Evaluation of proposed move for Water Right No. 15202

Proposed: Move water right no. 15202 ID3 to a new well location, 2,301 ft to the southwest.

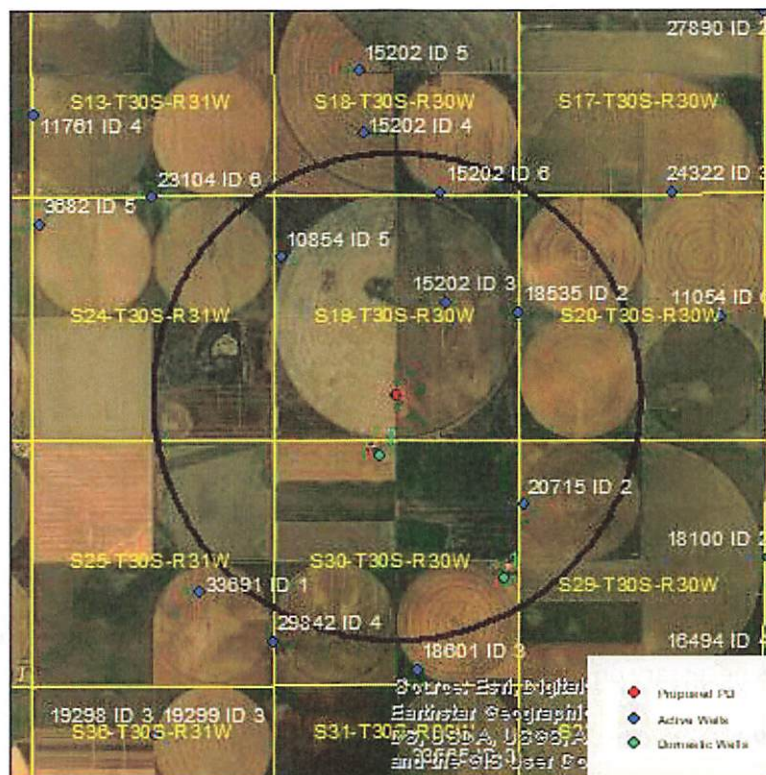
Wells within 1 mile: 15202 ID6, 10854, 18535, 20715, and two domestic wells, numbered on the above map.

Domestic 2: Drawdown from current location = 2.12 ft
Drawdown from proposed location = 9.05 ft
Net drawdown = **6.9 ft**

Net drawdown exceeds the drawdown allowance of 3.5 ft for the domestic well labeled “2” on the map. Critical well analysis is necessary on that well.

WELL TEST ANALYSIS

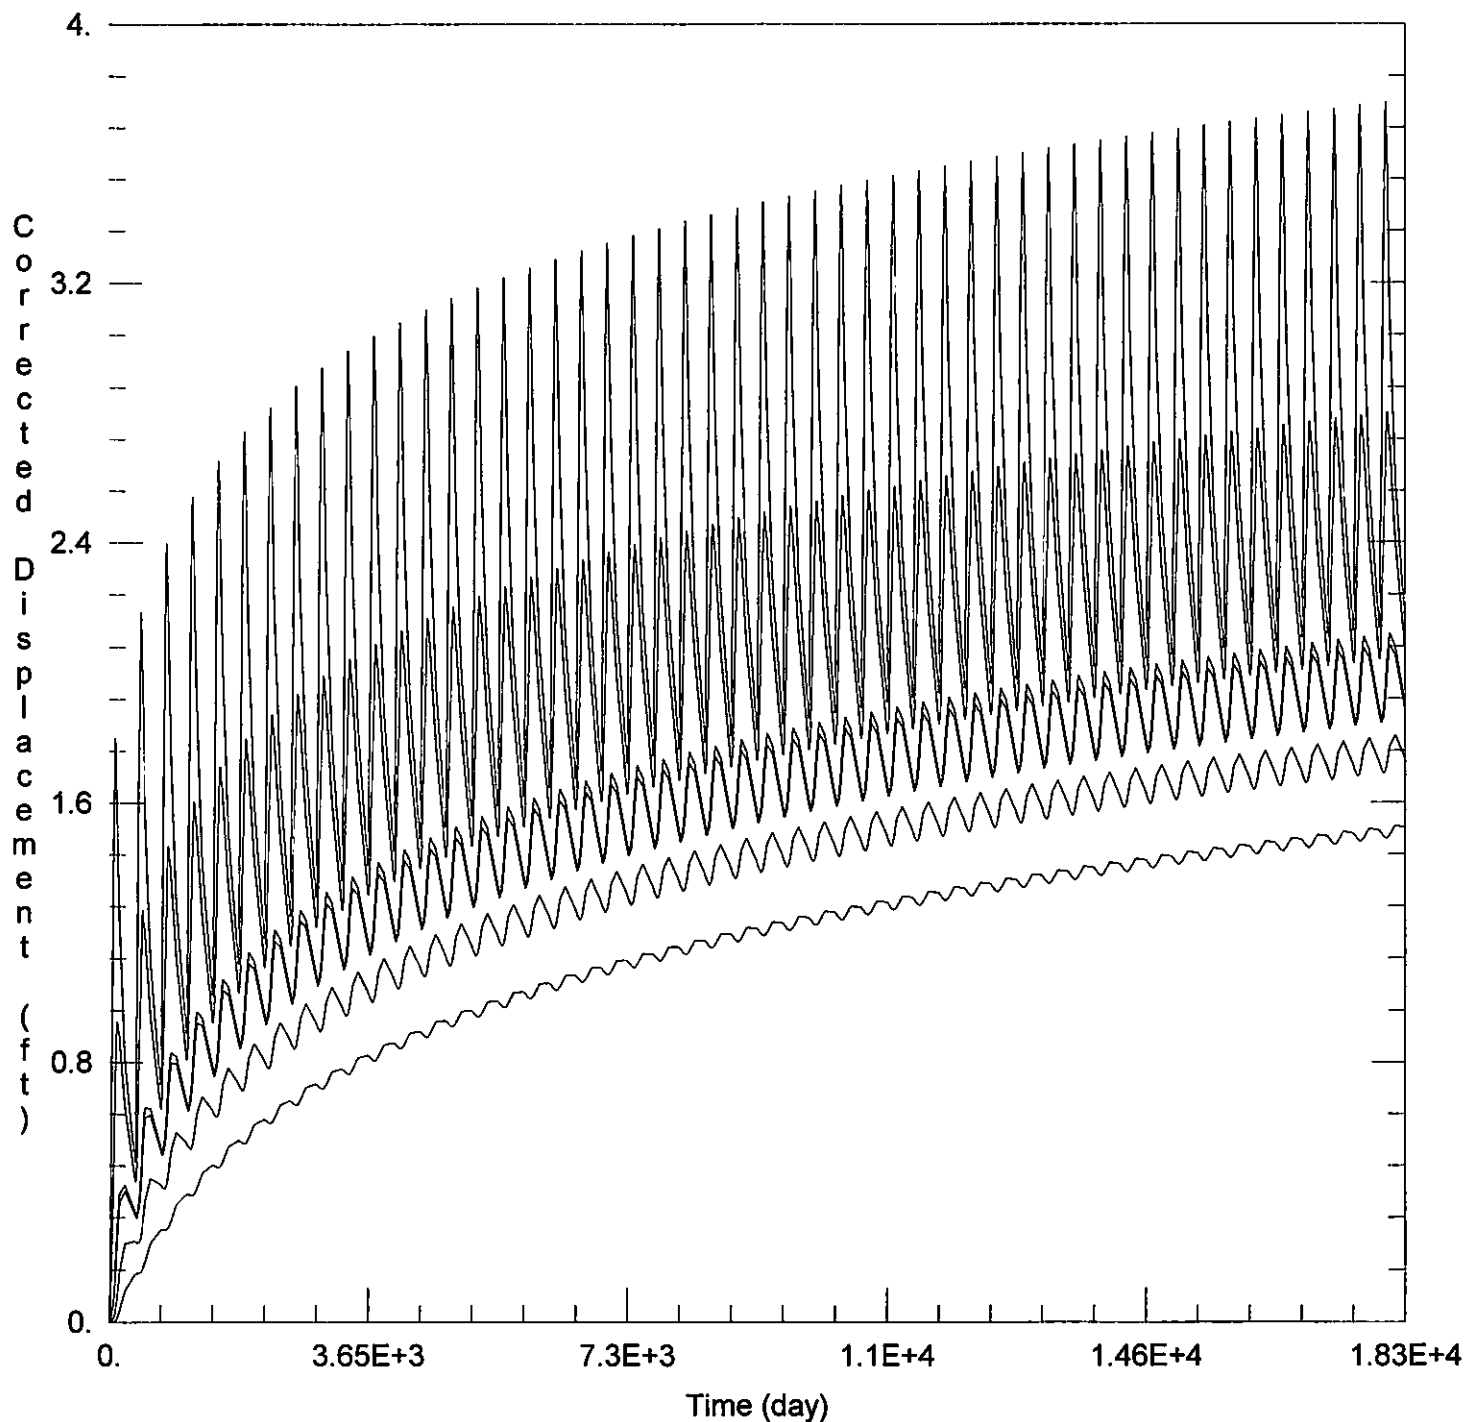
15202 ID6: Drawdown from current location = 2.80 ft
 Drawdown from proposed location = 3.74 ft
 Net drawdown = **0.9 ft**
